CERTIFICATE OF APPROPRIATENESS

Property: 1210 Cortlandt Street, Lot 16, Block 189, Houston Heights East Subdivision. The property includes a two-story wood frame, 1,598 square foot single-family residence situated on a 6,600 square foot corner lot.

Proposal: Alteration –

Maximum Lot Coverage (Addition and New Construction)

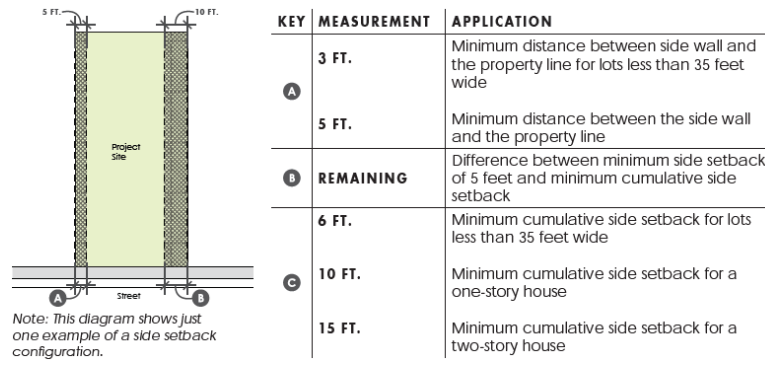
Existing Lot Size: 6,600. Max. Allowed: 2,640
 Proposed Lot Coverage: 2,992 HDGs call for excluding one-story garages attached to 264 SF and open porches. Meets at 2,608 SF. 32 SF under limit.

Side Setbacks (Addition and New Construction)

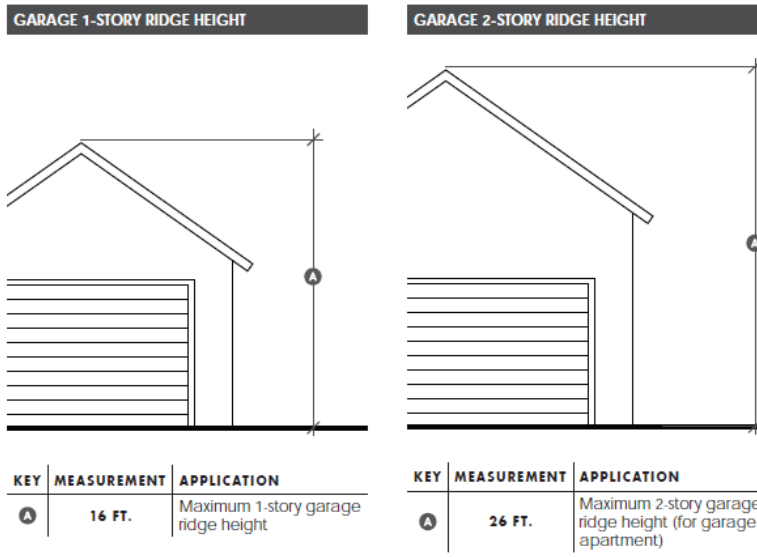
Proposed side setback (A): Matching existing on north side at 7'
 Proposed side setback (B): ~5' at side addition on south side except for garage portion at 3'.
 Cumulative side setback: Ranges from 12' to 24'8"
 Garage at 3' recommended for approval as not specifically precluded by the HDGs for one-story garage 5'10" from rear property line.

Side Wall Length and Insets (Addition and New Construction)

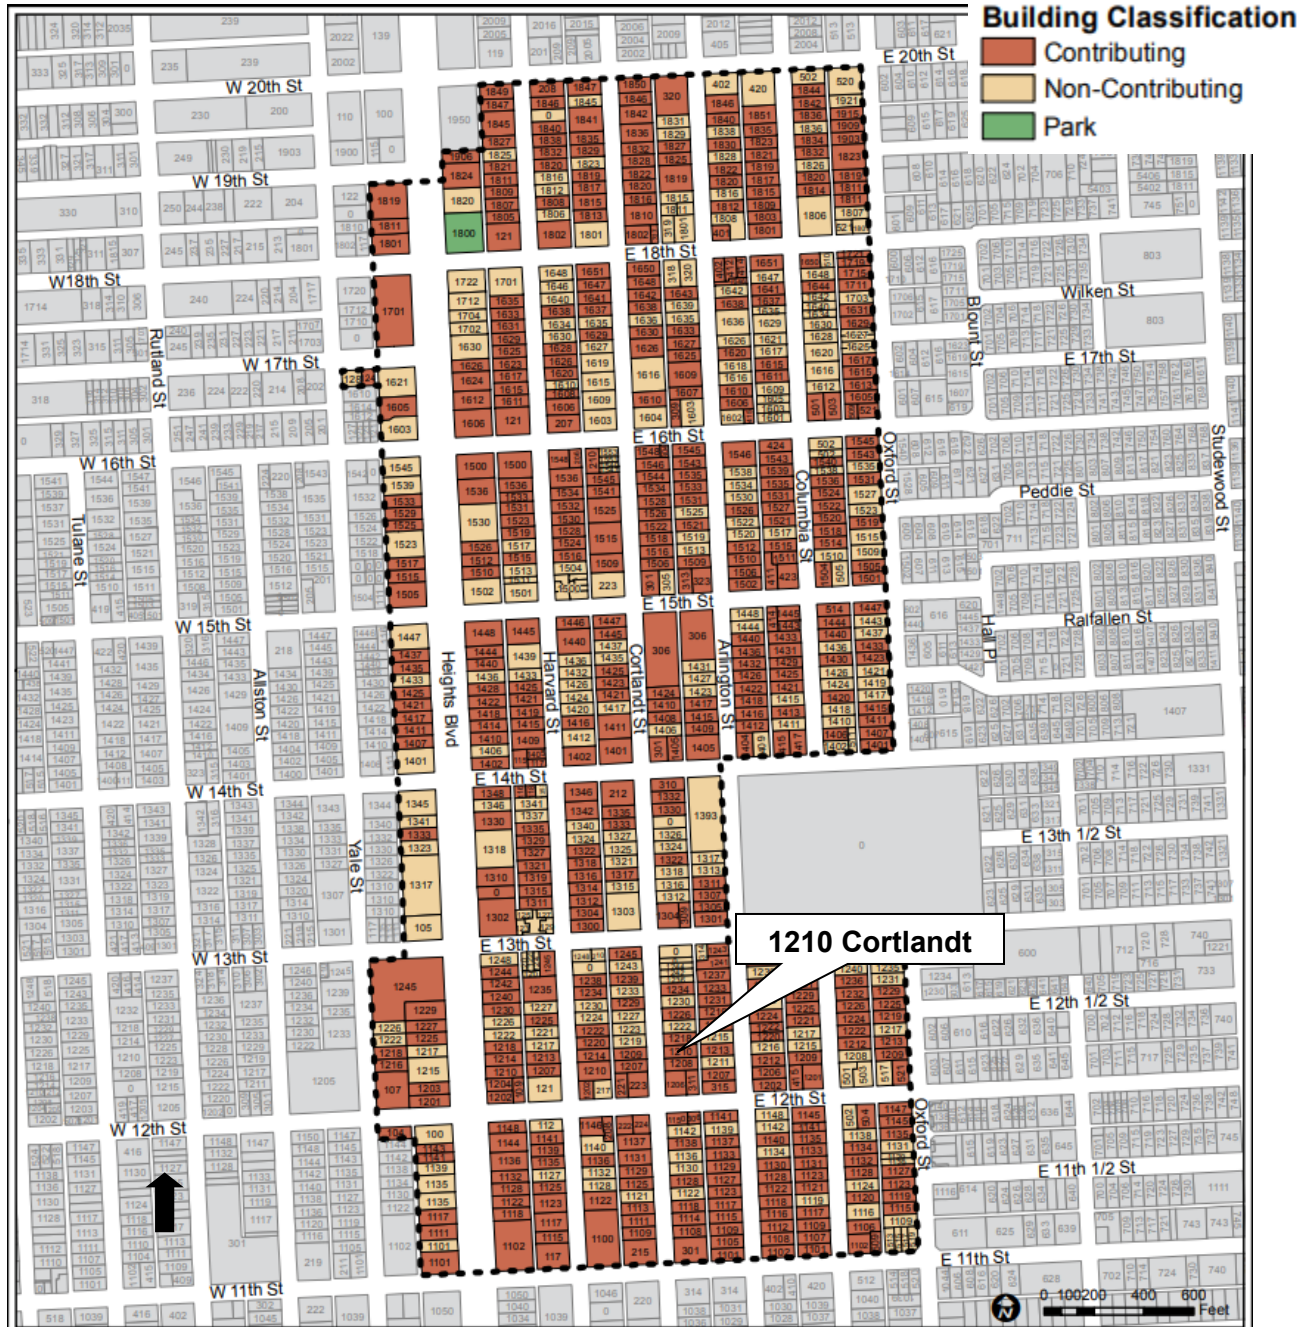
South side elevation pre-existing exceeds sidewall length at 54'10". Applicant proposes to lessen this excessive length by bumping out at ~33'10" from the front wall.

Figure 7 - Seam area Original House to Addition

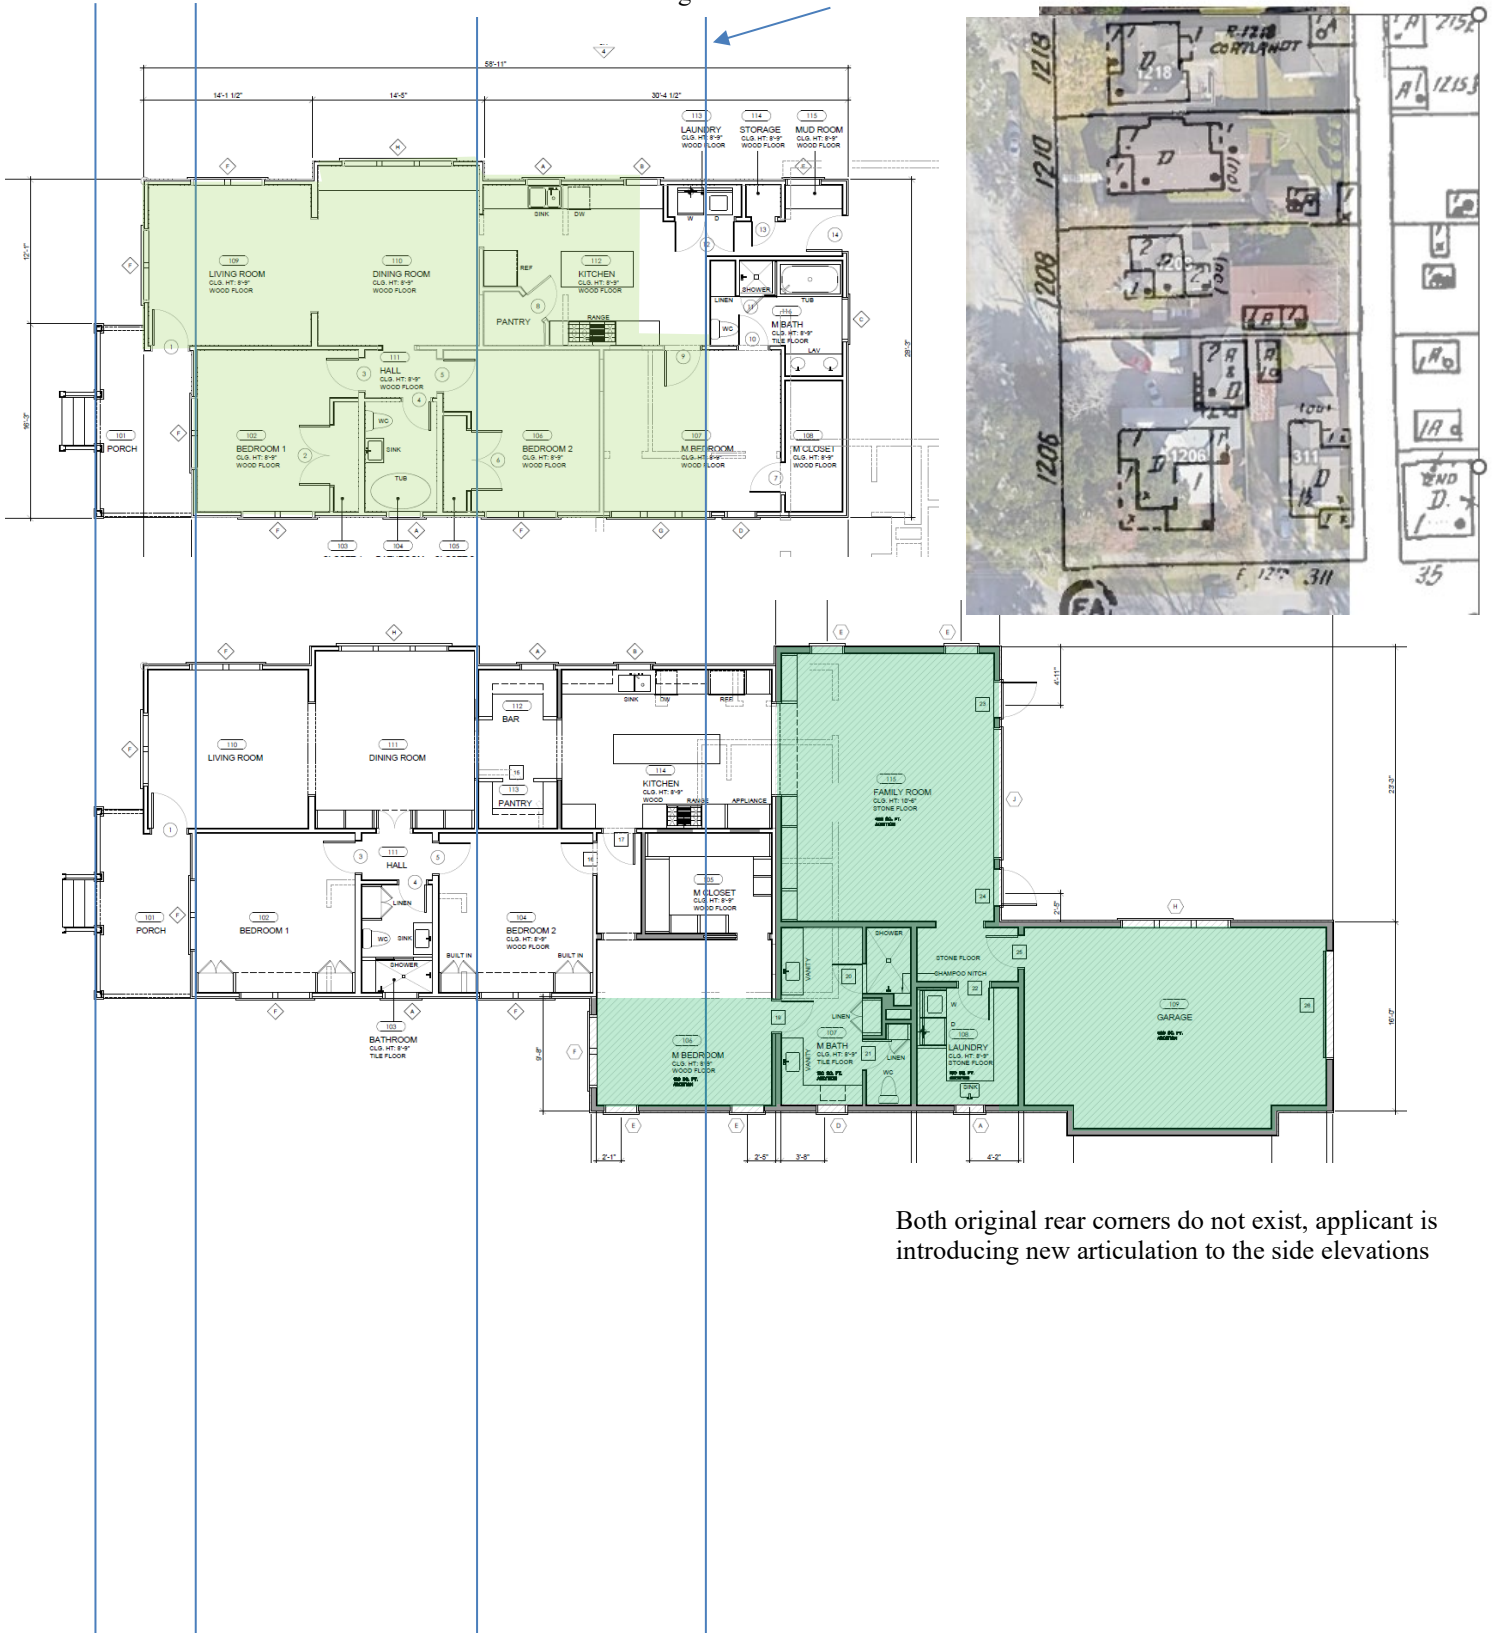
Existing house has elongated original walls. This line is close to the original rear wall.

Both original rear corners do not exist, applicant is introducing new articulation to the side elevations
